ST. CHARLES <small>SINCE 1834</small>	HISTORIC PRESERVATION COMMISSION AGENDA ITEM EXECUTIVE SUMMARY			
	Agenda Item Title/Address:	COA: 402 N 4 th Ave		
	Proposal:	Garage		
	Petitioner:	Jim Dulaney/ Silverthorne Homes		
Please check appropriate box (x)				
	PUBLIC HEARING		MEETING 7/17/19	X
AGENDA ITEM CATEGORY:				
X	Certificate of Appropriateness (COA)		Façade Improvement Plan	
	Preliminary Review		Landmark/District Designation	
	Discussion Item		Commission Business	
ATTACHMENTS:				
COA Application				
4/3/19 Meeting Minutes				
Design Drawings				
EXECUTIVE SUMMARY:				
<p>At the 4/3/19 meeting, the Commission approved a COA for a new single family home located at 402 N 4th Ave. The design style is a single story craftsman.</p> <p>The applicant is now proposing to change the previously approved interior lot facing garage, into a front facing garage. The garage will be setback 5ft from the front of the house, and comply with all setback standards.</p> <p>The applicant will provide a site plan to City Staff before the meeting.</p>

a. 402 N. 4th Ave.

1 FRONT ELEVATION
SCALE: 1/8" = 1'-0"

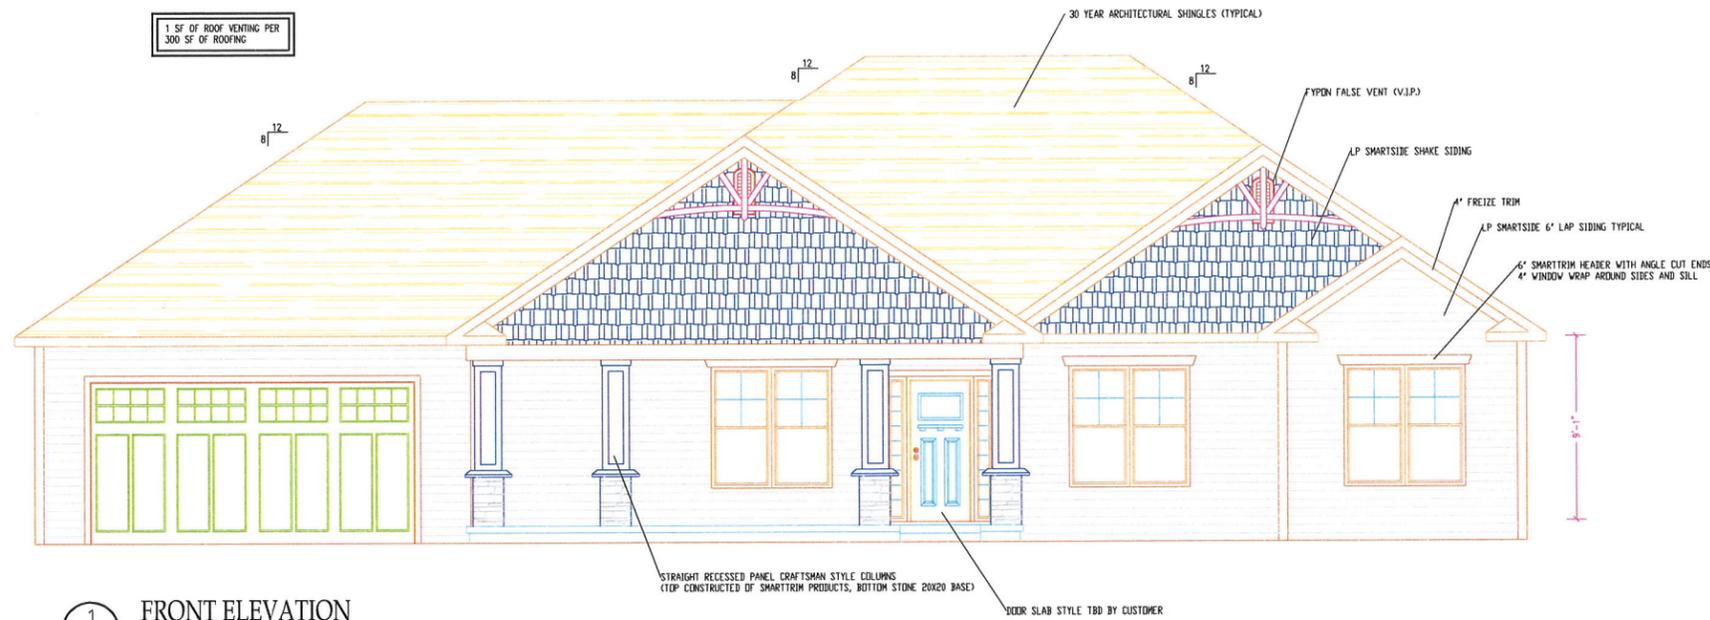
The Commission discussed preliminary plans at a previous meeting. The applicant reviewed the adjustments he made based on feedback from that meeting. Dr. Smunt suggested adding another 6 inches of frieze board to give the roof line better definition. He felt the gables were overpowered by shingles. Mr. Kessler shared some pictures showing proportionate corner boards and frieze boards against the gable.

A motion was made by Dr. Smunt and seconded by Mr. Pretz with a unanimous voice vote to approve the COA with the addition of a pediment decoration in the gable of the roof per the picture sent to City Staff.
